DEVELOPMENT DETERMINATION PANEL MEETING

WEDNESDAY 18 DECEMBER 2019

ITEM 3.1 **MOD2019/0241 - 4 LAURA STREET, SEAFORTH -
MODIFICATION OF DEVELOPMENT CONSENT DA148/2014
GRANTED FOR ALTERATIONS AND ADDITIONS TO AN
EXISTING DWELLING INCLUDING A SEA WALL**

APPLICATION FOR MODIFICATION ASSESSMENT REPORT

Photo 1. Existing overlooking from the top terrace area to the western property.

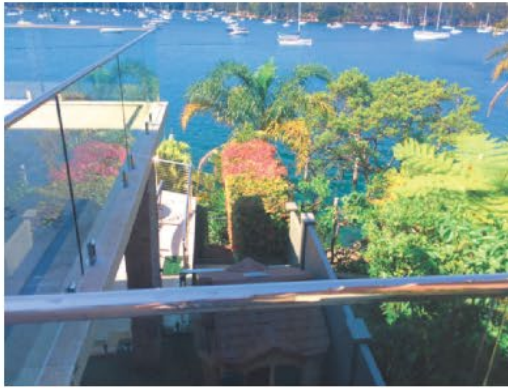
The proposed inclinator track runs largely parallel to the western side boundary, where existing overlooking exists. Screening landscaping adjoins the western side boundary to property, No. 5 Laura Street thereby mitigating direct viewing between the properties. See photo 1, 2 and 3 below.

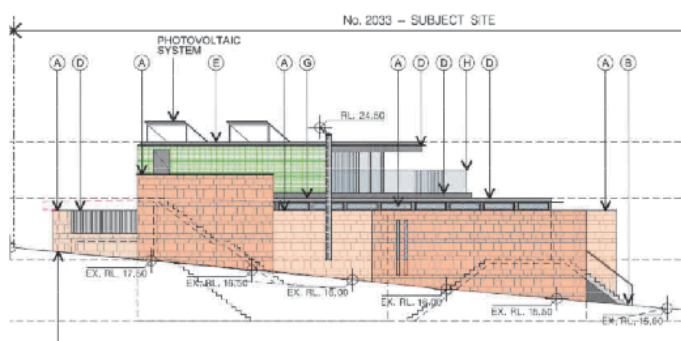
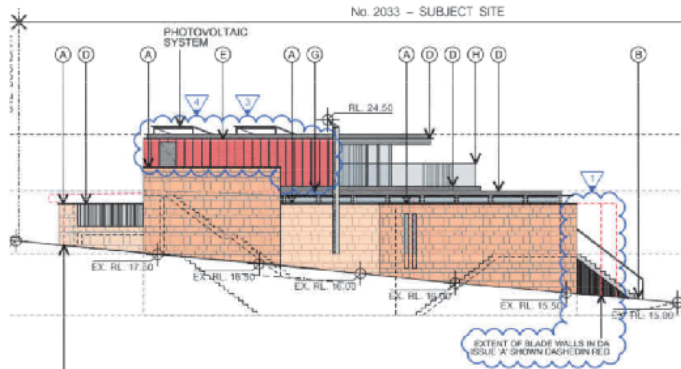
- *The proposal will have an impact upon views for surrounding properties.*

A detailed assessment of the view impact for surrounding properties has been undertaken later within this report, under Part C1.3 View Sharing. Overall, the proposed development is considered to be reasonable in the context and results in a satisfactory view sharing outcome.

Figure 1 - Full extent of view obtained from loungeroom looking north from a seated position.

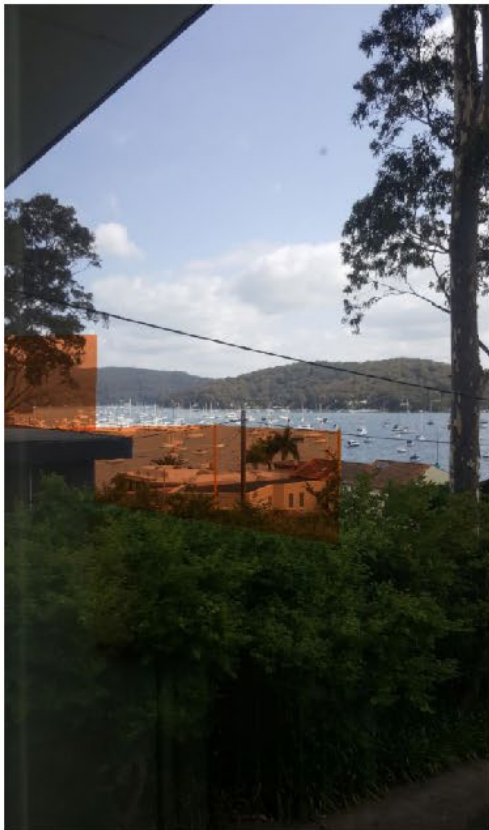
The main view that is to be impacted is obtained from the living room and obtained across the side boundary (Figure 1) looking towards the north-west. The views are obtained from both a standing and seated position. The view is also impacted from a bedroom (Figure 2) which has the same aspect as the living room windows and obtained from a standing and seated position.

Figure 22: Extract south elevation (Dwellings 1-4) showing breaches to 8.5m height plane

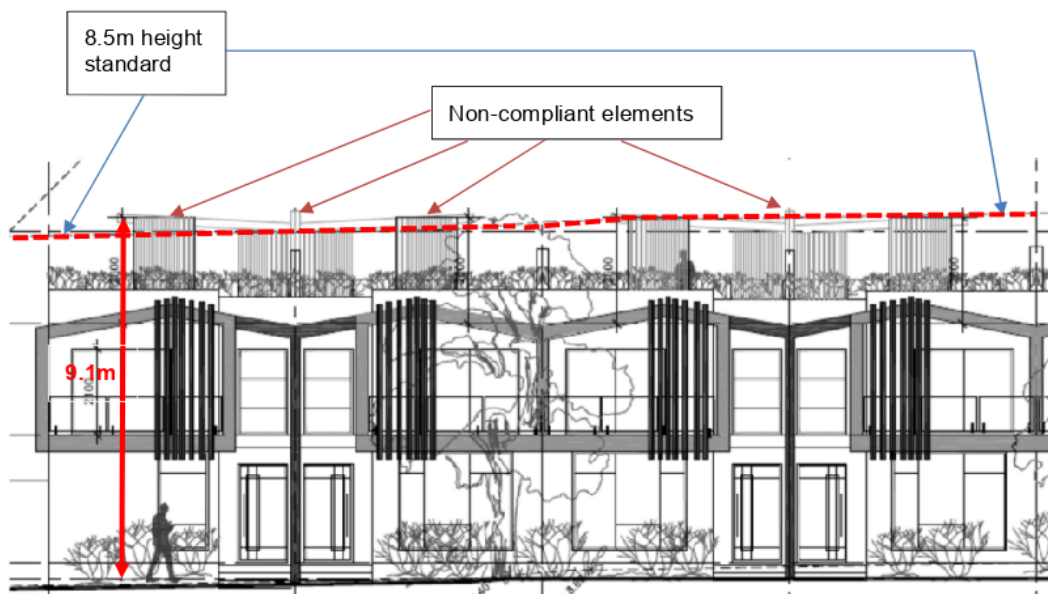
The maximum height of the proposed development is 9.1m, occurring at the uppermost point of the western end of the roof canopy on Dwelling 1 at the western end of the development. The development also includes other lesser breaches to height standard comprising parts of lift and stair overruns and roof canopy structures. The minor breaches to the height standard are shown below at Figure 22 where an extract of dwellings 1-4 is taken, (noting no breach occurs at Dwellings 5-6).
